## Application for Waiver from Construction Standards for Public Water Systems

Water System Name	USFS Cloud Cap/Cooper Spur	PWSID	92634
Project or Facility	Cloud Cap Inn Spring Reconstruction	and Waterlines	County Hood
River			
Need for waiver iden	tified: Water System Survey	Date of Survey

Construction standard requested to be waived: OAR 333-061-0050 (2)(b)(A)(ii)

# CLOUD CAP INN WATER SYSTEM RENOVATION

**SPRING SITE PROPOSED IMPROVEMENTS** SECTIONS

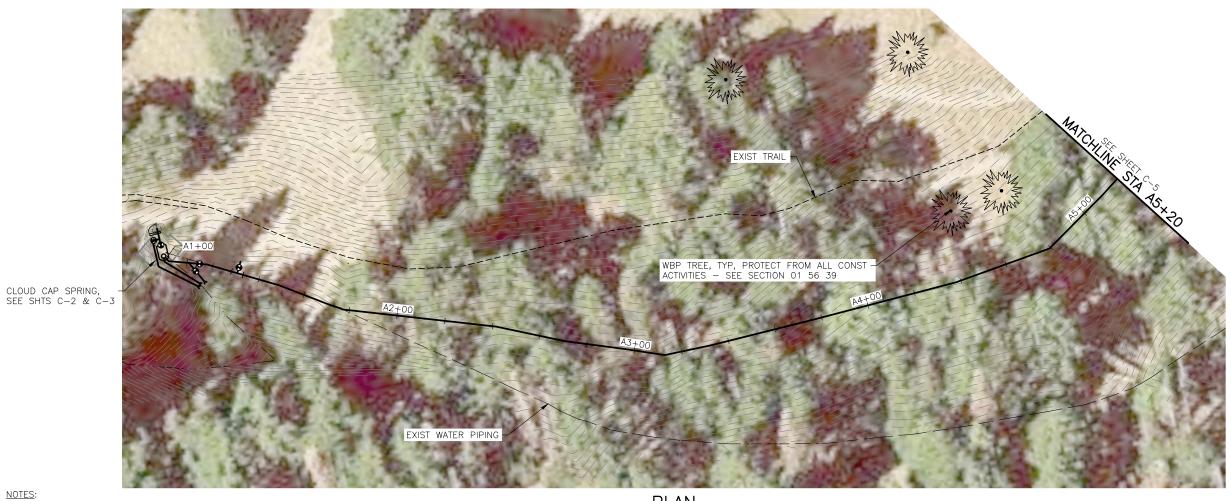
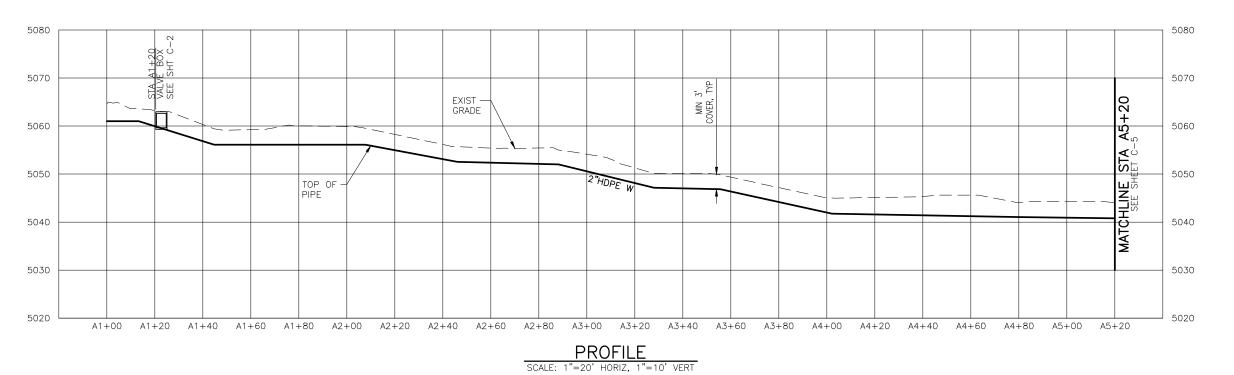
The spring and spring box does not include a security fence to prevent access by animals or unauthorized personnel.

We have concluded that a security fence would be unnecessary in this particular situation given the spring collection system and spring box will be buried. Additionally, the spring is adjacent to Mt Hood Trail #600 and a fence may draw more attention to the site.

The spring collection system and spring box will be buried with the final grade providing greater than 3-feet of cover/backfill. The spring box design access includes a water tight lockable manhole cover to prevent water intrusion and unauthorize access, see Sheet C-3 in the attached design drawings.

OHA Use Or	nly
Waiver ID 418-2022	
Entered into waiver database x	
	a waterproof locked springbox lid is an acceptable sing a fence in this situation.
After due consideration the above requested waiver from OAR 333-061-0050 is hereby:	rom the construction standards of
	ure inspections show signs of vandalism or amination, a fence may be required.
Kari Salis	3/18/22
Drinking Water Regional Manager Signature Oregon Health Authority	Date
Waiver database updated x
